UNITED STATES PATENT AND TRADEMARK OFFICE

APPLICATION NO.	FILING DATE	FIRST NAMED INVENTOR	ATTORNEY DOCKET NO.	CONFIRMATION NO.
09/474,299	12/29/1999	MARCEL F.C. SCHEMMANN	PHA-23.939	2088

Office Action Summary

FIG. 6

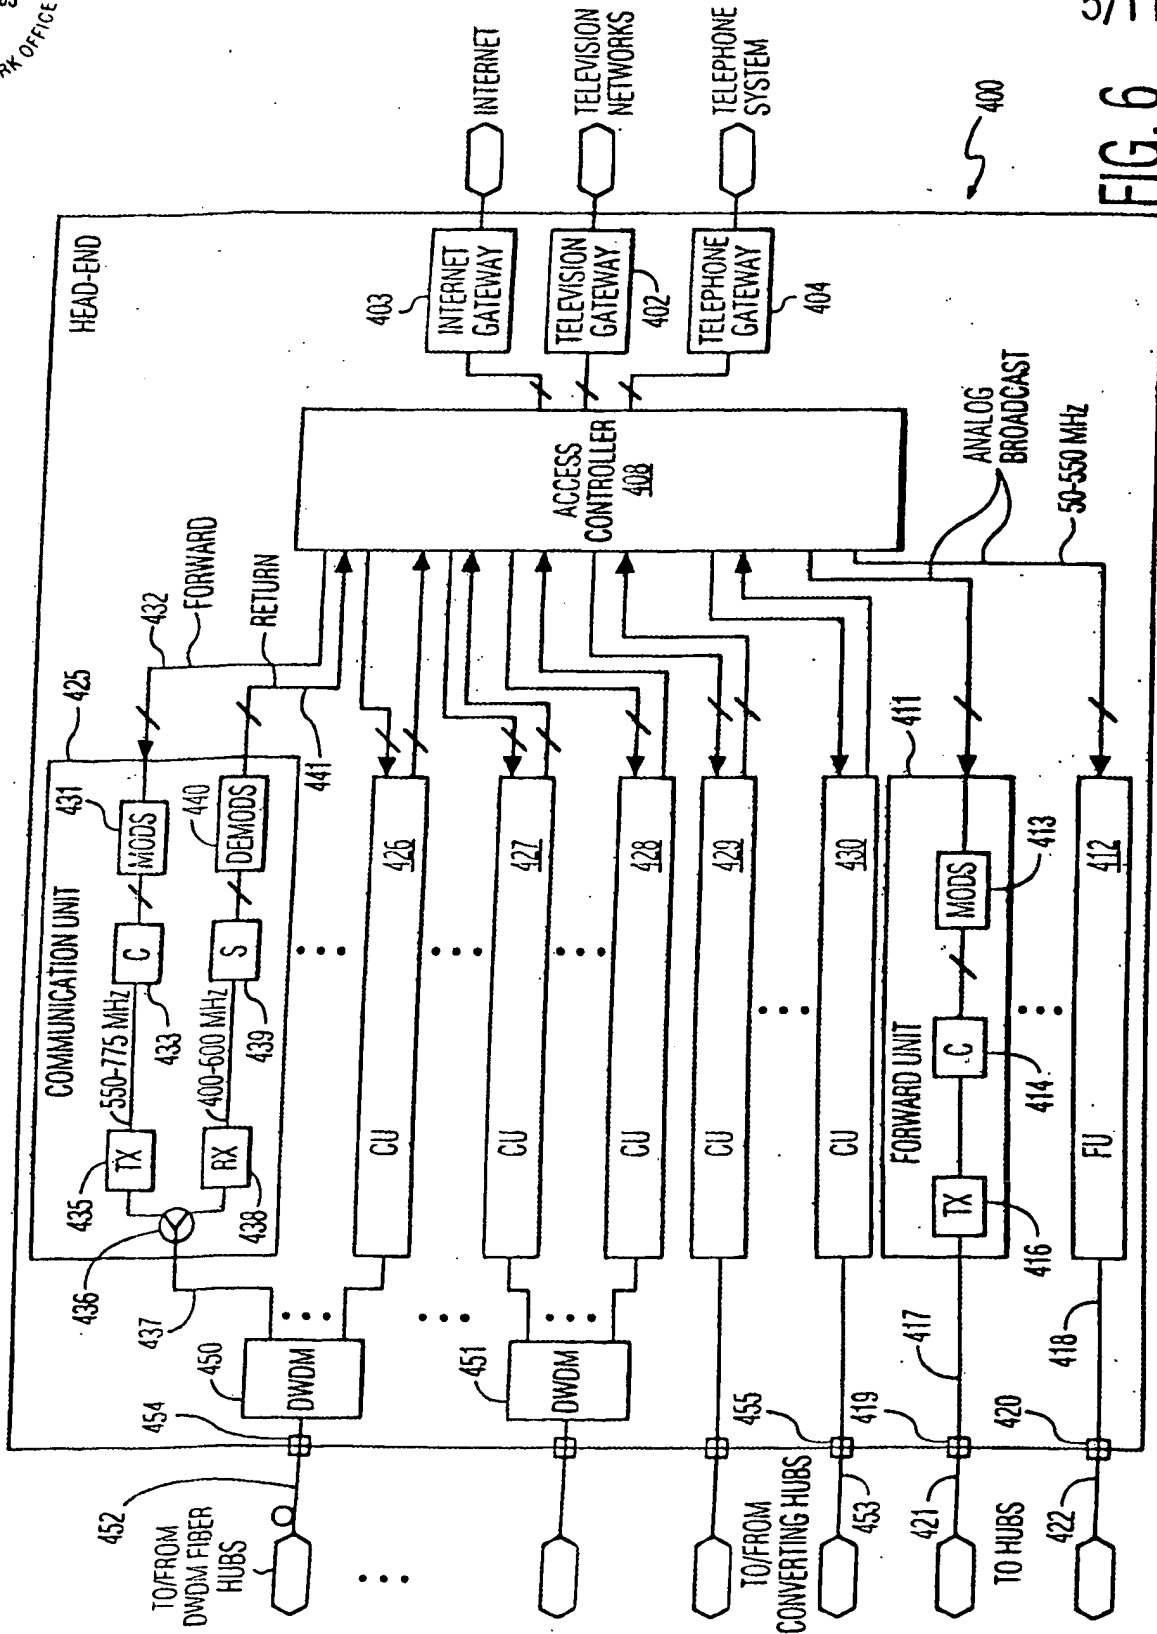
1. Applicant's compliance with the objections to the drawings in the previous Office Action (mailed on 18 November 2004) is noted and appreciated. Replacement drawing sheets were received on 18 February 2005. Fig. 6 is approved. However, Figs. 5 and 7 are still disapproved. Upon further review of the drawings and the specification together, the Office has noticed numerous informalities. Some examples include:

Approved by DSK
11 OCTOBER 2005

FIG. 7

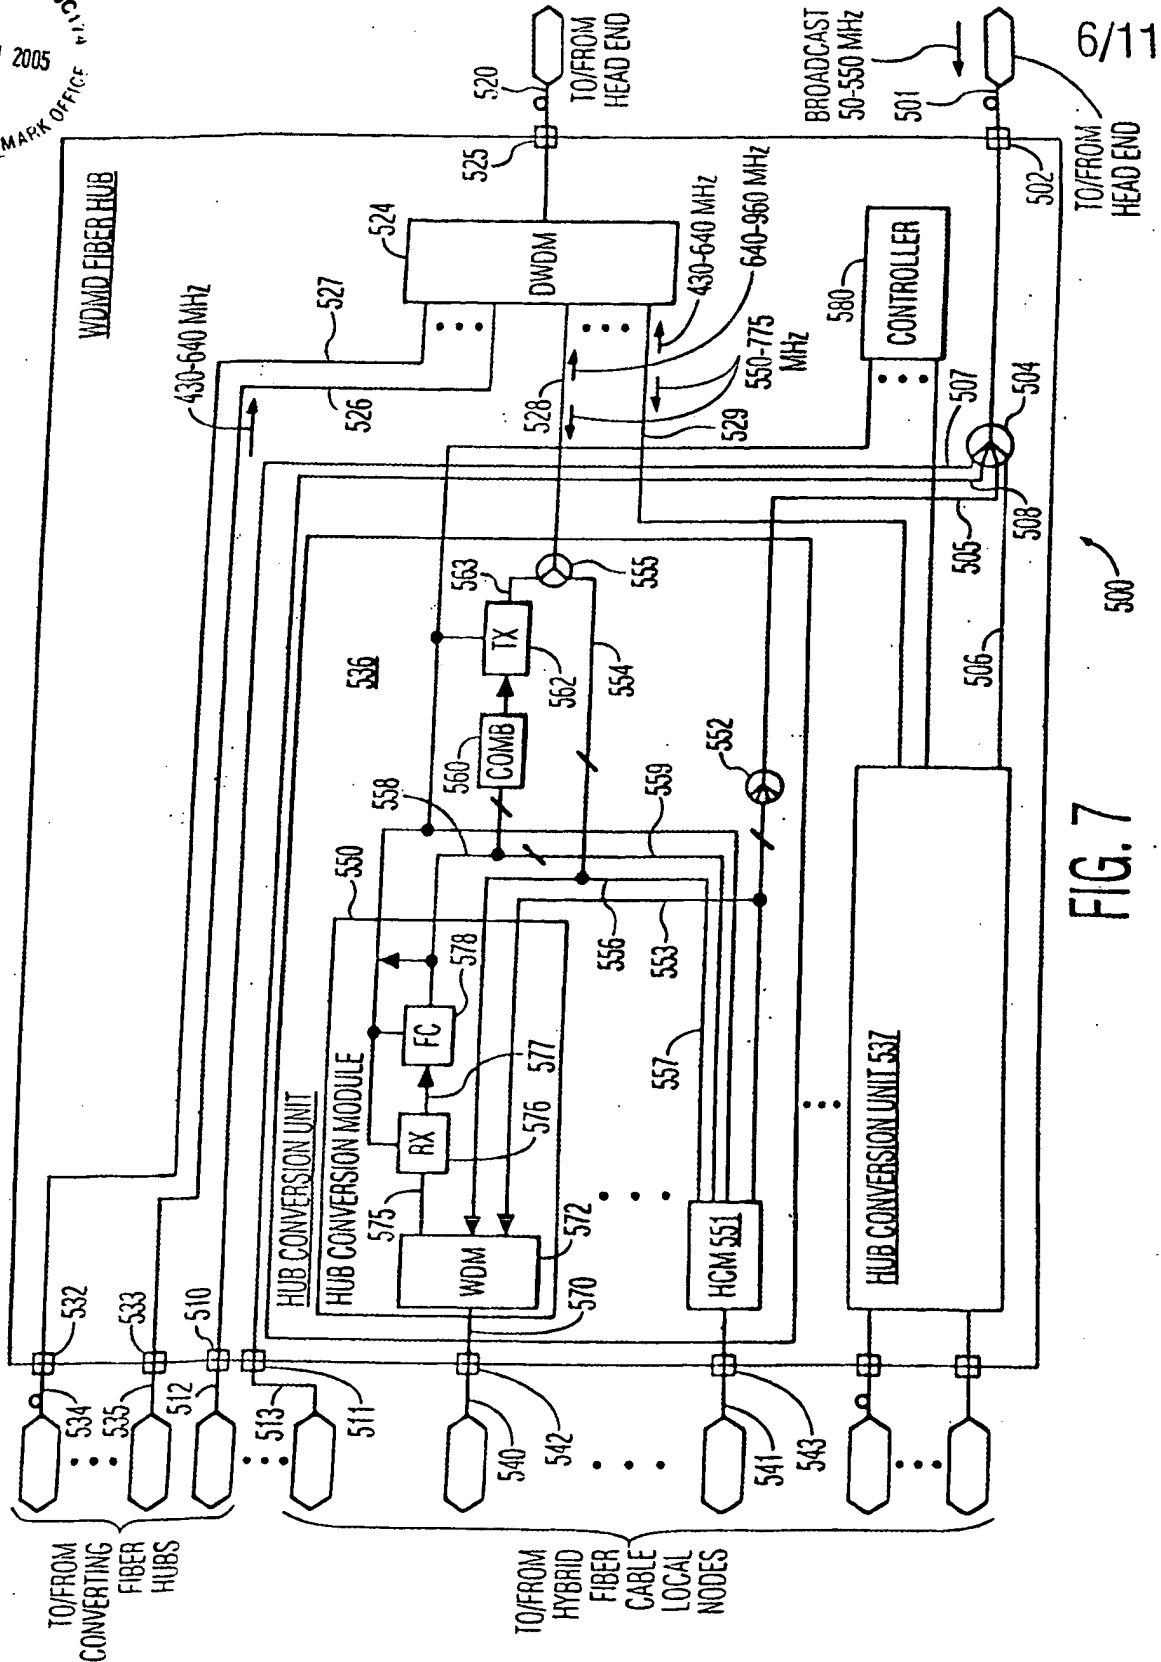
In replacement Fig. 7 (filed on 18 February 2005), reference character "554" appears to be located in the wrong location. The bridging paragraph of p. 35-36 indicates that "554" should label a path that is connected to optical splitter 552.

Disapproved by DSK
11 OCTOBER 2005
